Appendix 6: Geotechnical Investigation and RFI response letter

CH00417

PC200072: TRICES ROAD REZONING GROUP PRIVATE PLAN CHANGE- RESPONSE TO REQUEST FOR FURTHER INFORMATION

PRIVATE PLAN CHANGE TO THE
OPERATIVE SELWYN DISTRICT
PLAN AND SUBMISSION ON
SELWYN DISTRICT PLAN REVIEW,
TRICES ROAD AREA,
PREBBLETON

Borelog for well M36/20546

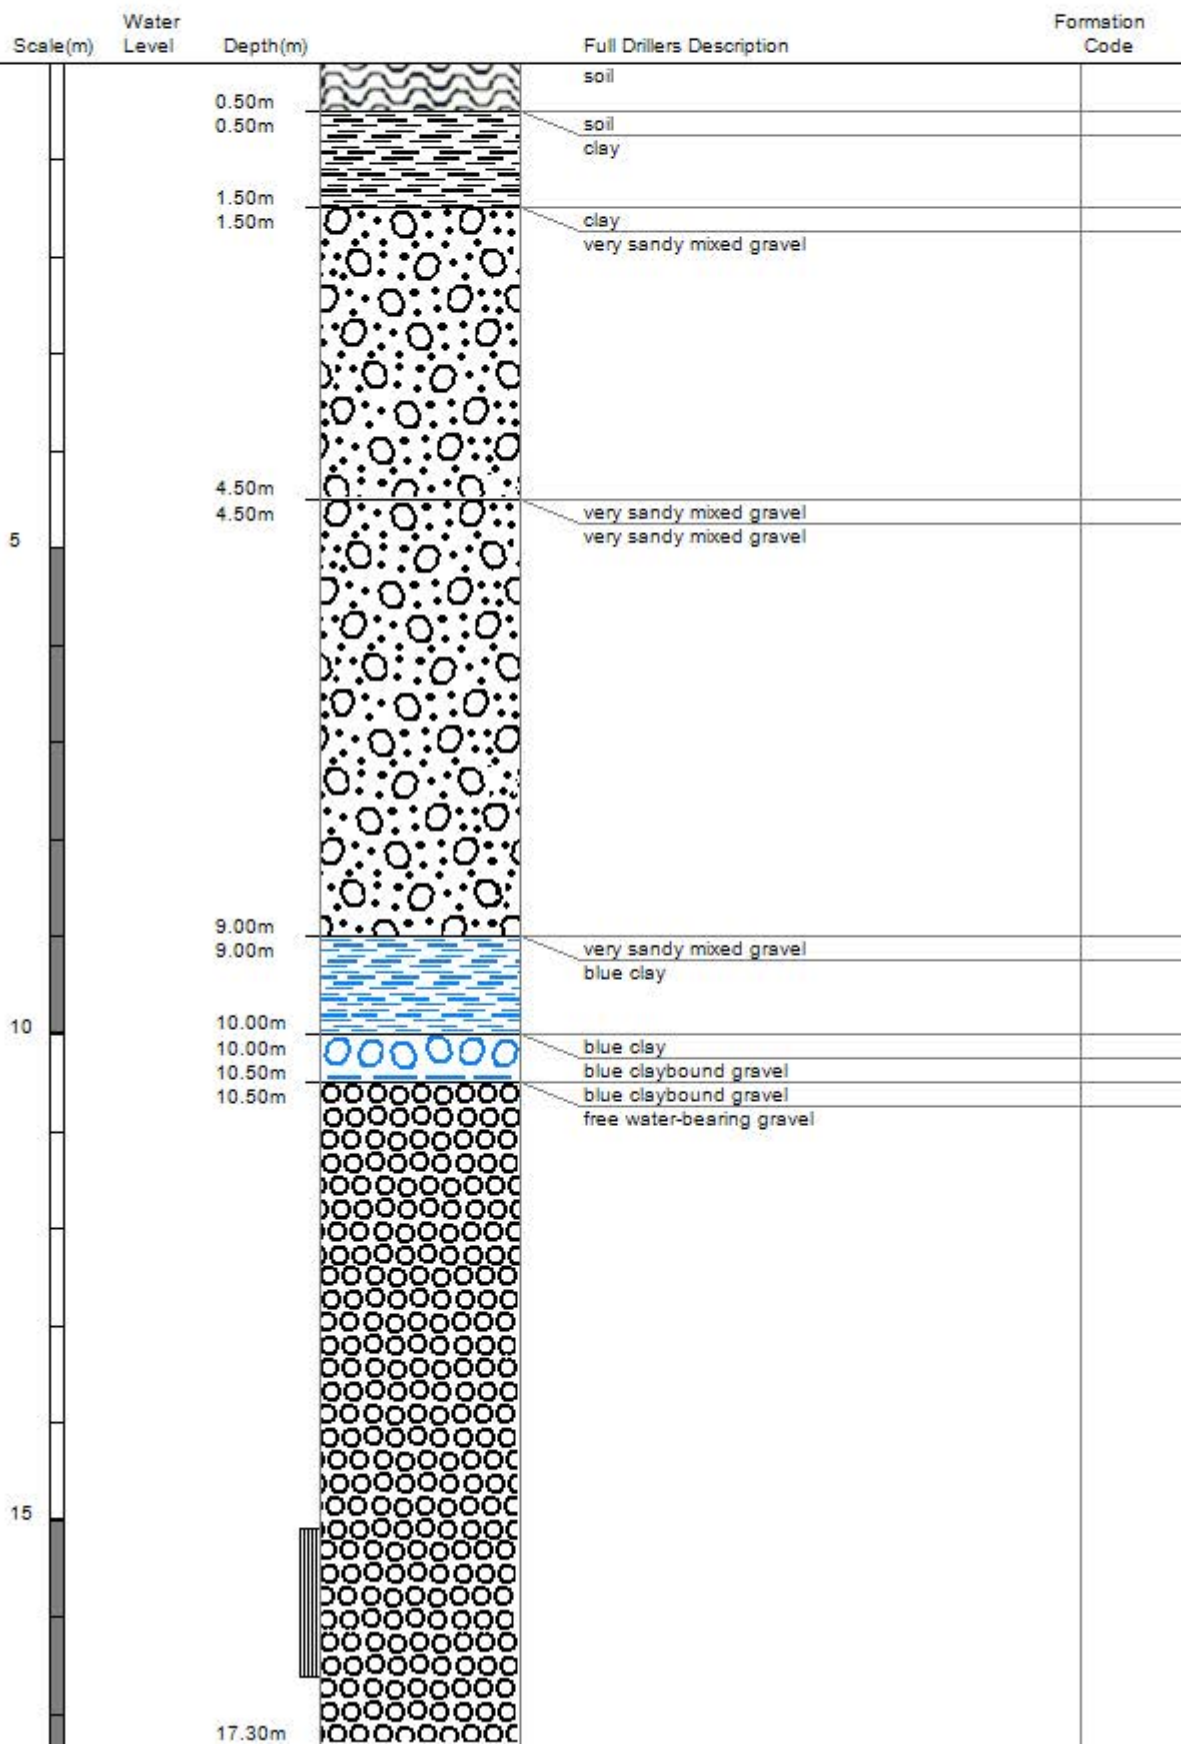
“Please supply the Ecan well logs and locations used to model the gravels as extending to 18m depth (8.3).”

The logs of the relevant existing water bore logs, sourced from ECan records, are appended to this letter.

Drawing G00417-02

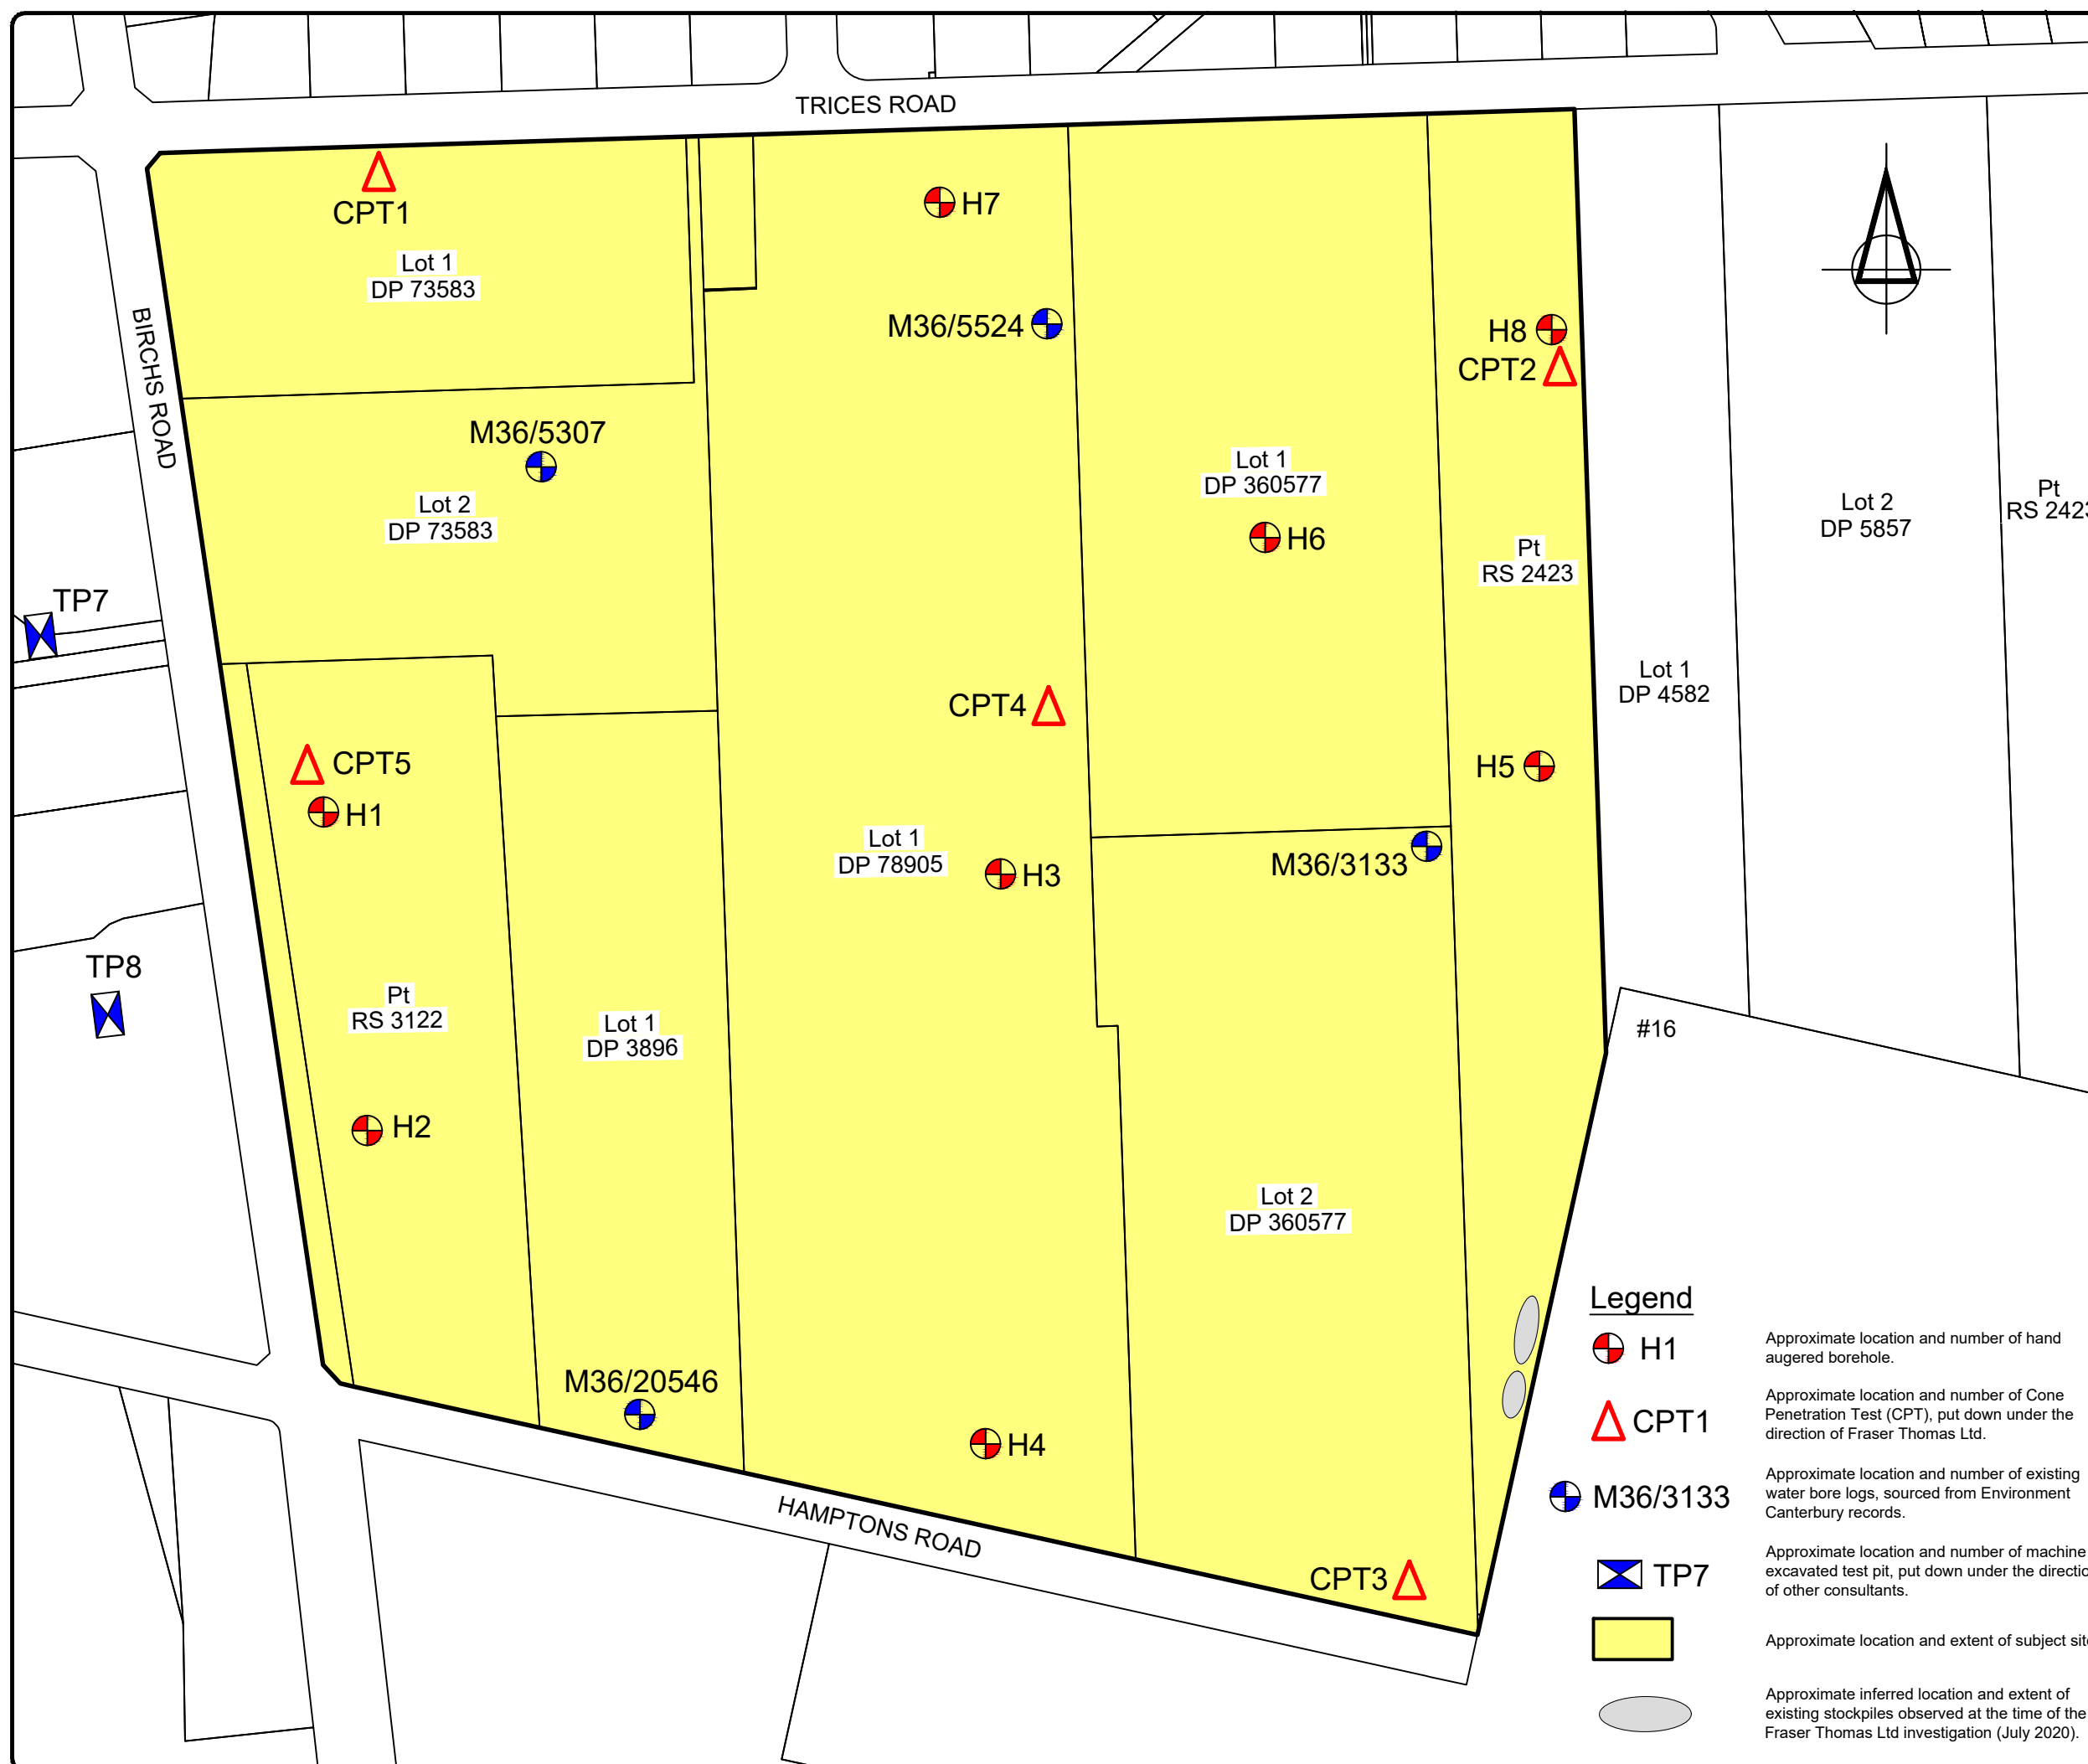
“Please supply the test data from the NZGD (location and logs) used to help identify the soil profile (8.3).”

The test pits are located at a site abutting the western site boundary. The approximate inferred location and extent of these test pits are shown on the appended Fraser Thomas Ltd drawing G00417-02.

The approximate inferred location and extent of the relevant water bores are shown on the appended Fraser Thomas Ltd drawing G00417-02.
